**Ordinance Number: 1365-23, File Number: 19-24**

**RTA Tunnel Membrane Replacement- Addendum 3**

**NARRATIVE:** Addendum 3 contains the following:

**WALL PATCHING NOTES:**

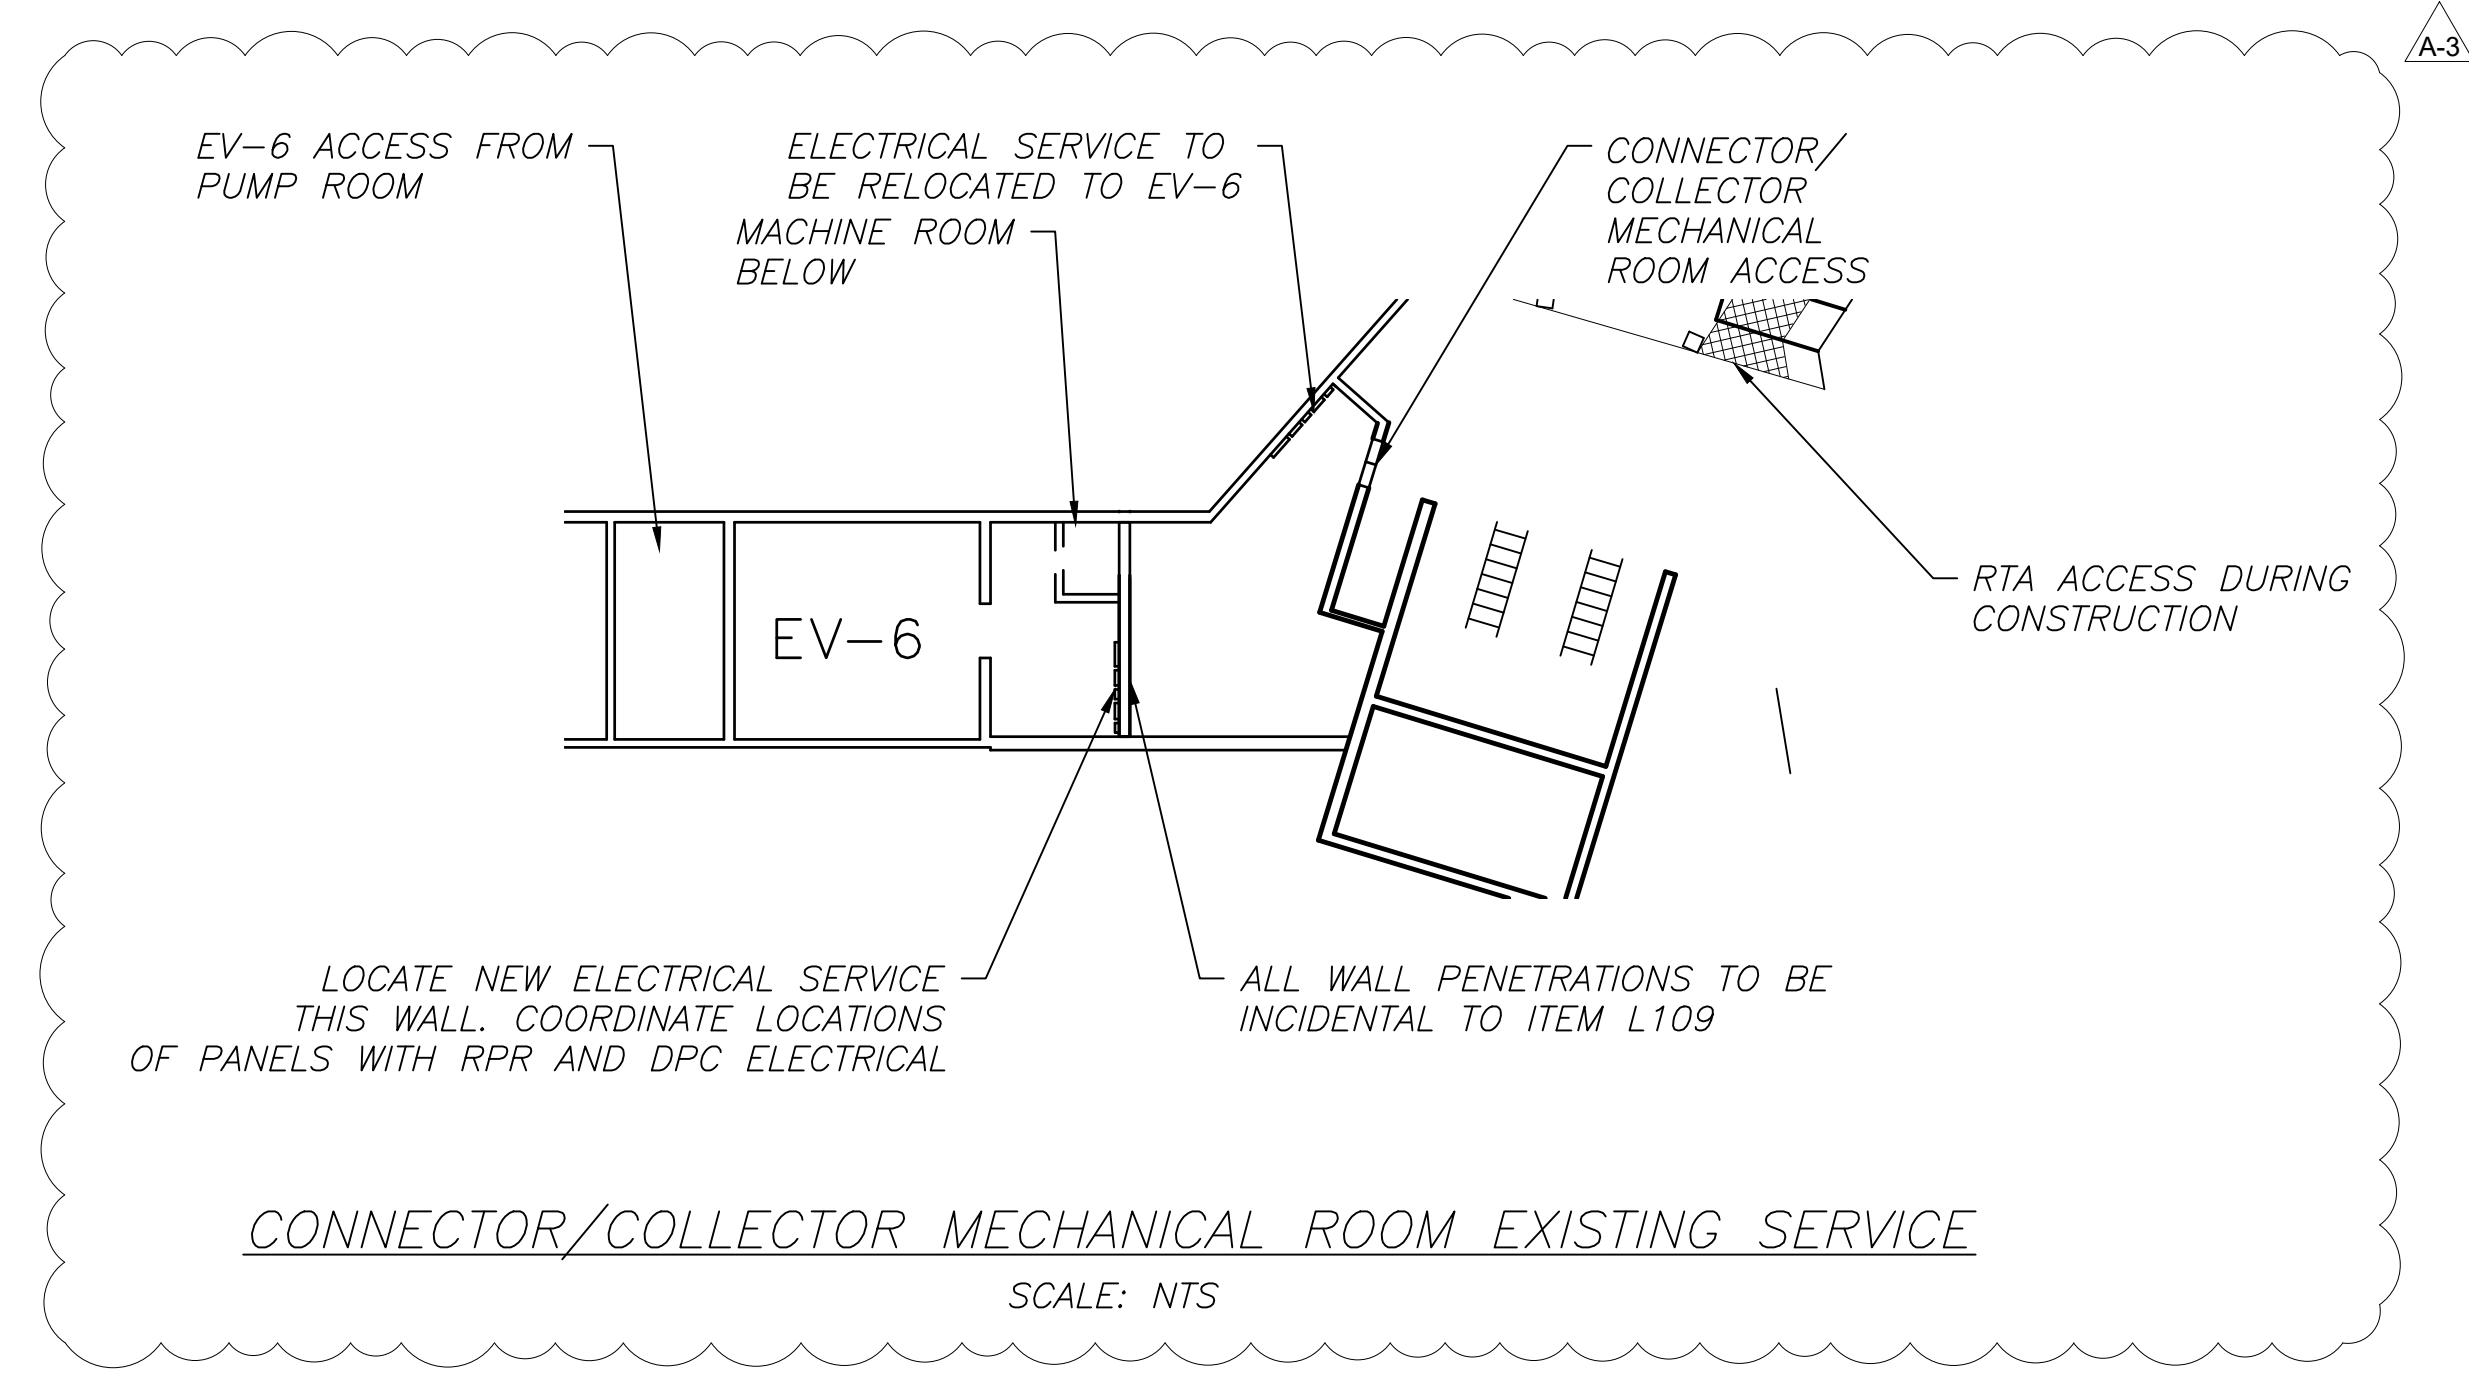
1. THE CONTRACTOR TO FOLLOW ODOT ITEM 519 - PATCHING CONCRETE STRUCTURES SPECIFICATIONS WHEN PERFORMING THE PATCHING WORK.
2. THE LOCATIONS SHOWN ON THE PLANS ARE APPROXIMATE. NO DETAILED INSPECTION WAS PERFORMED. PATCH AREAS TO BE FIELD LOCATED BY THE CONTRACTOR AND APPROVED BY THE RESIDENT PROJECT REPRESENTATIVE (RPR). THE CONTRACTOR WILL BE PAID FOR THE ACTUAL SQUARE FOOT AREA PATCHED.

Project Title RTA TUNNEL MEMBRANE REPLACEMENT			
Sheet Title PLUMBING MODIFICATIONS			
Designed: MSI	Drawn: MSI	Checked: LGW	Approved: LGW
Scale: AS SHOWN		Project No.: 198348	
Date: FEBRUARY 2024		Sheet: C-27

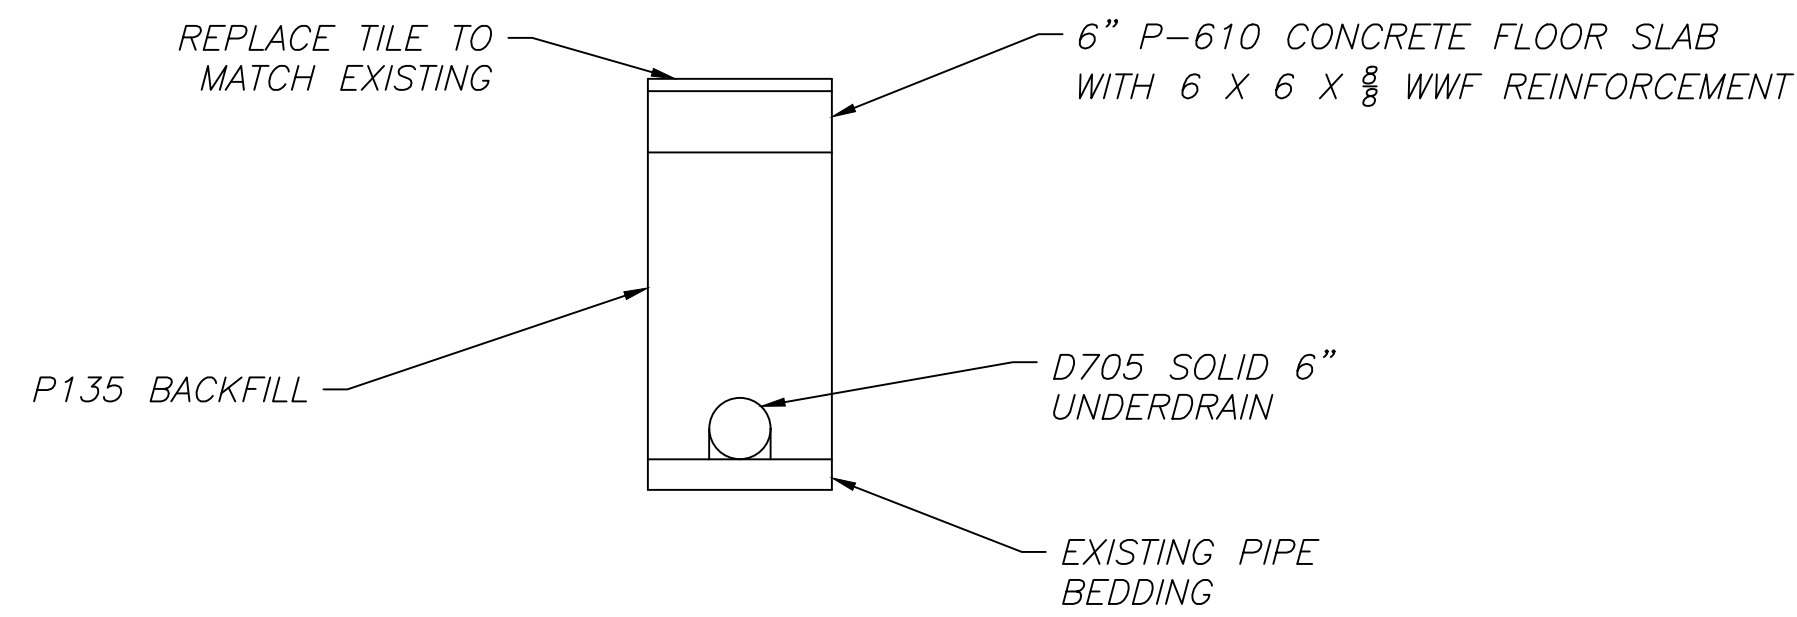
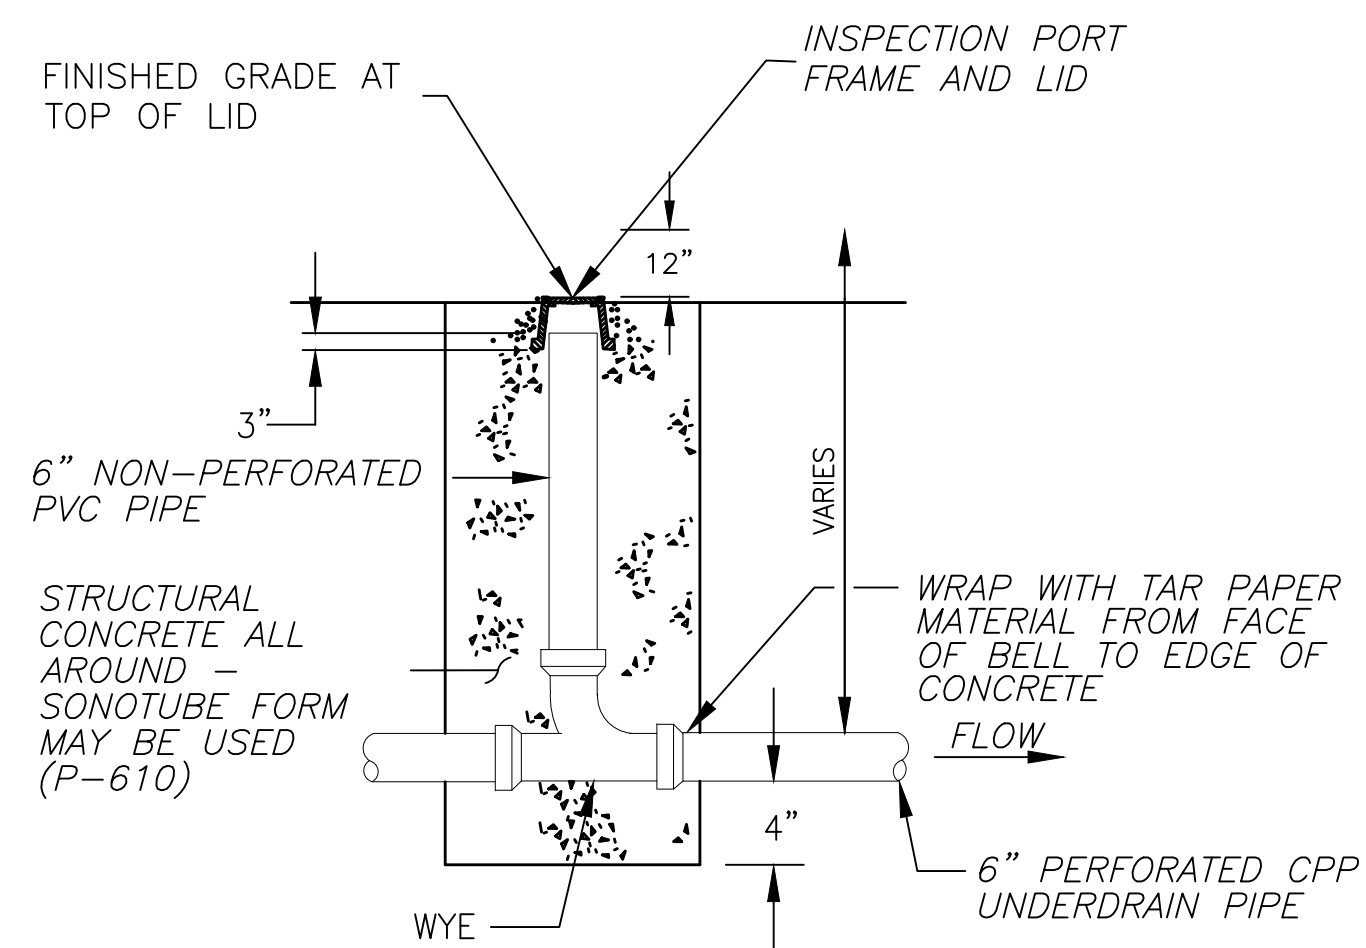
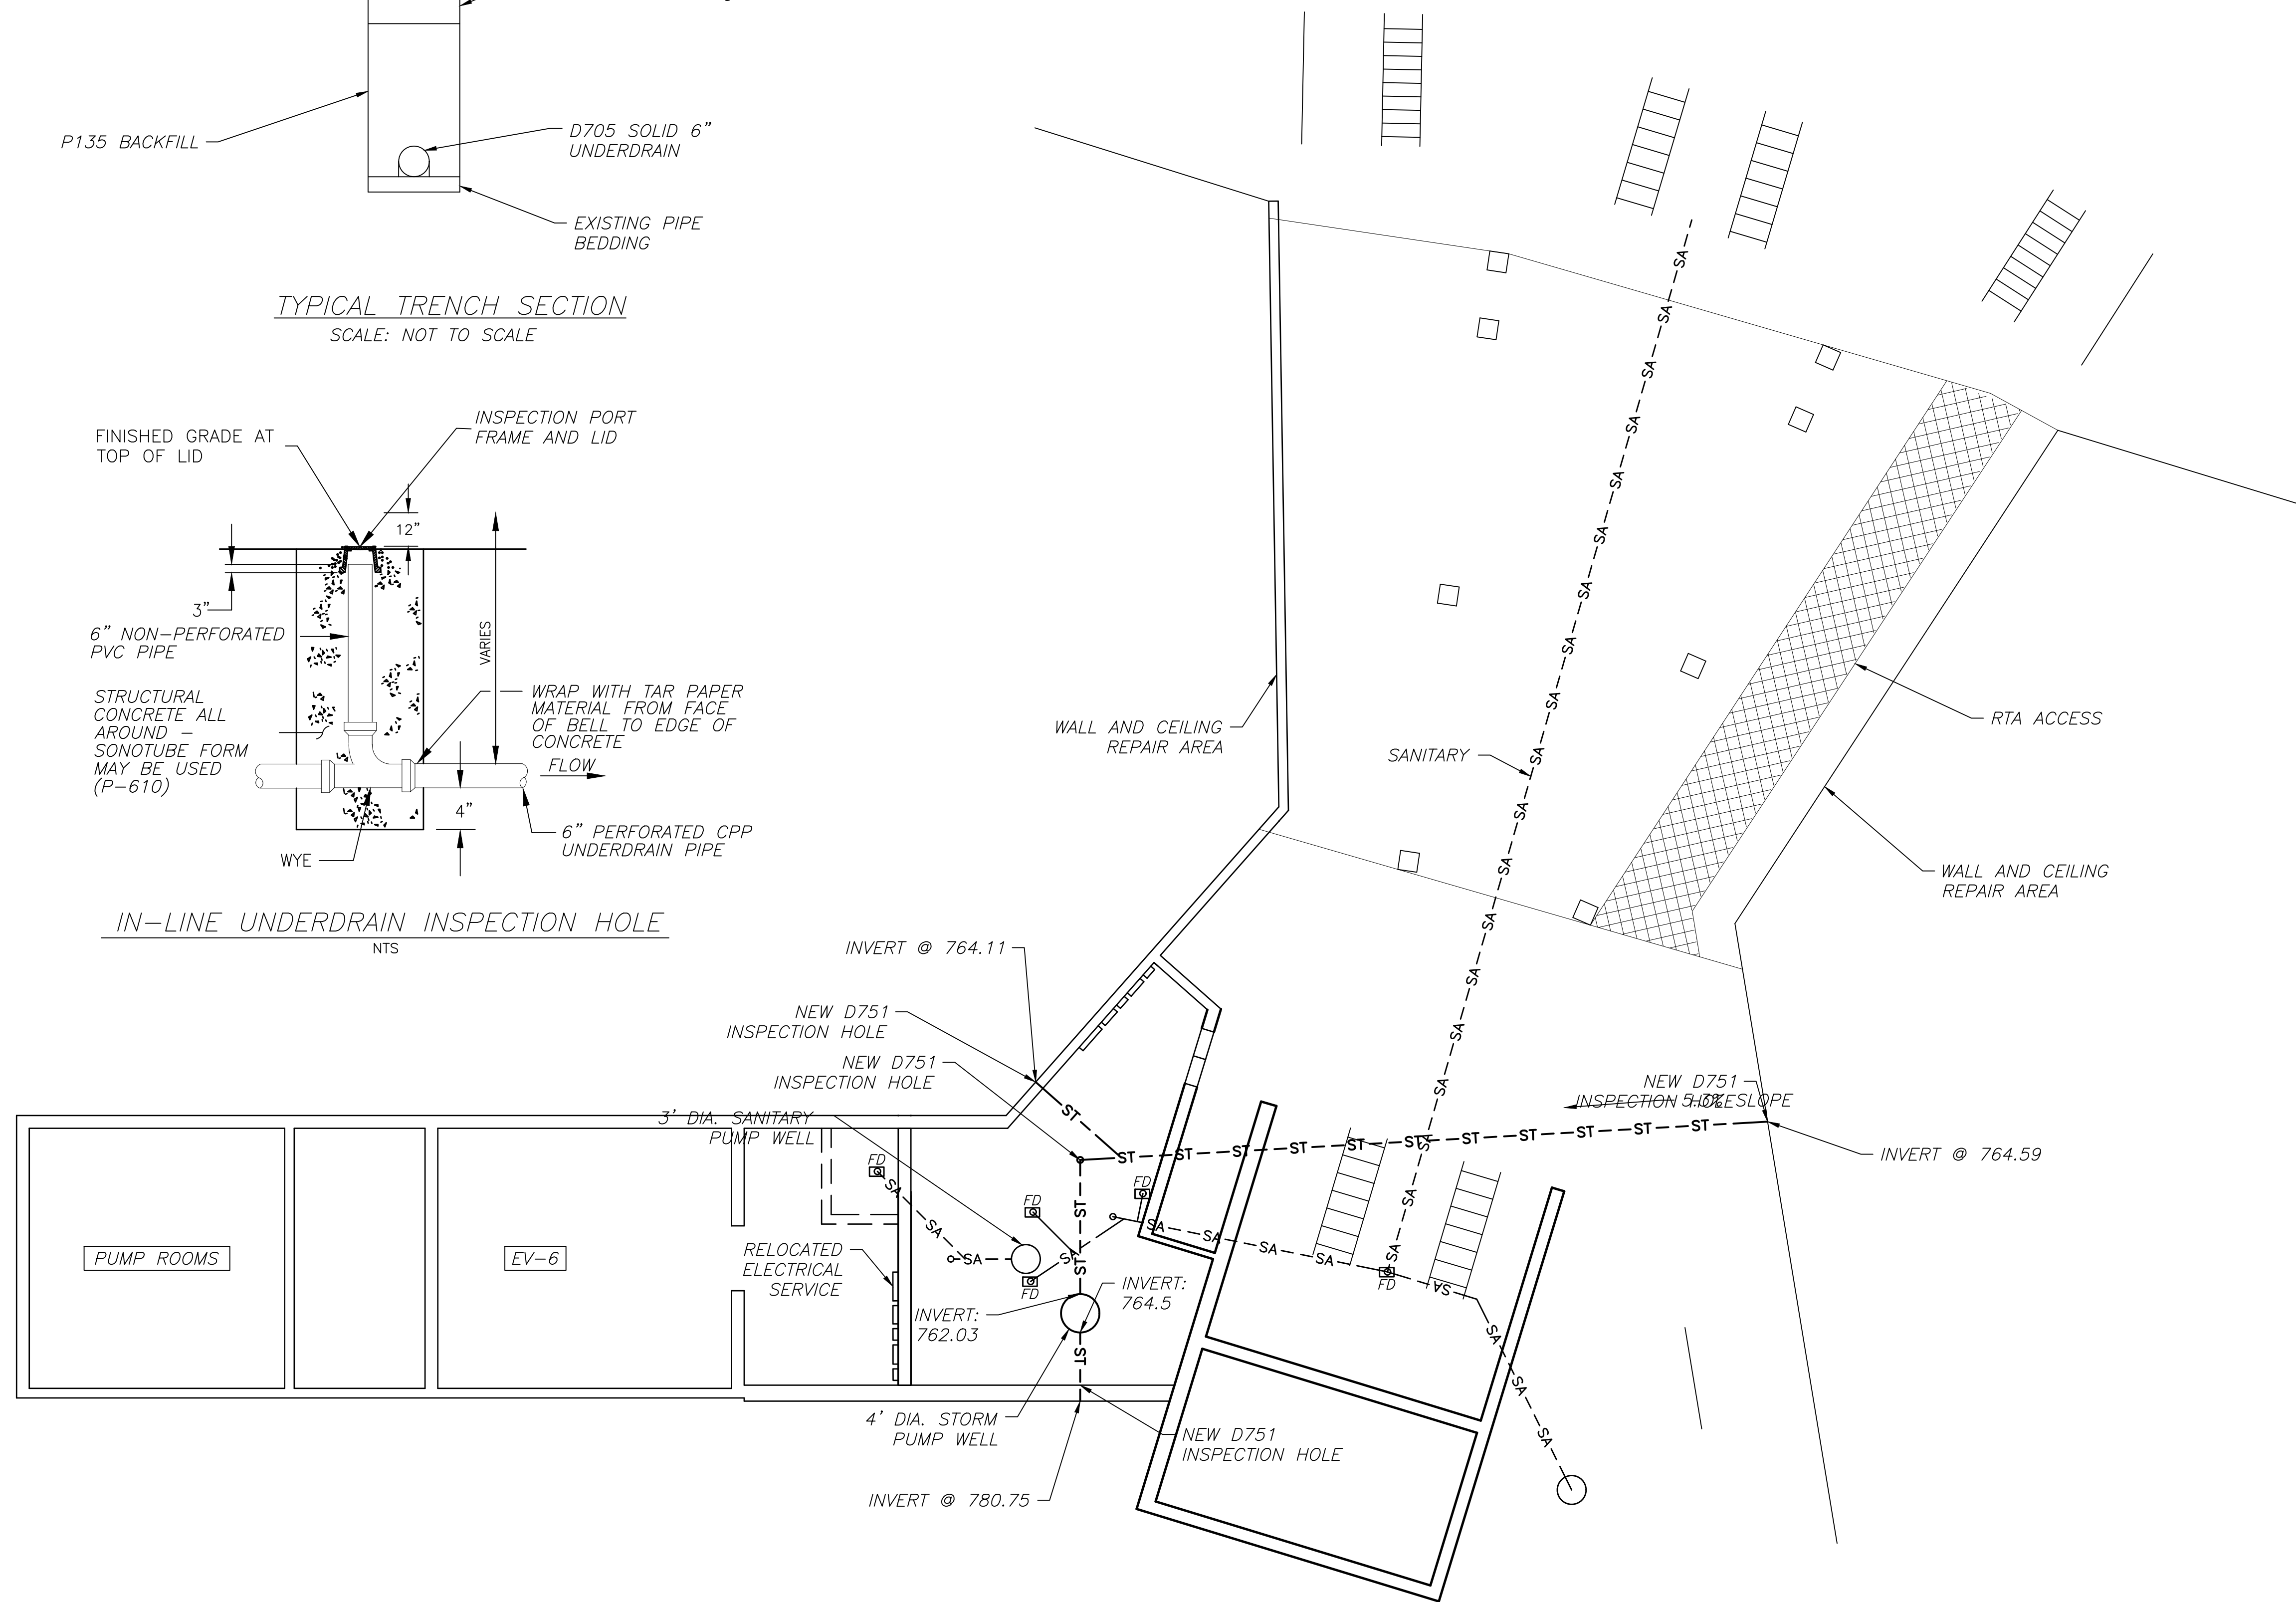
- According to the available as built information, the footer drains are connected to a 6" pipe beneath the mechanical room floor.
- The project will locate the drain and replace the existing pipe with a solid 8" PVC pipe at the same location. Pipe to be sloped to drain.
- Refer to the project documents for more information

NOTE: NEW SHEET ADDED FOR ADDENDUM A-3.
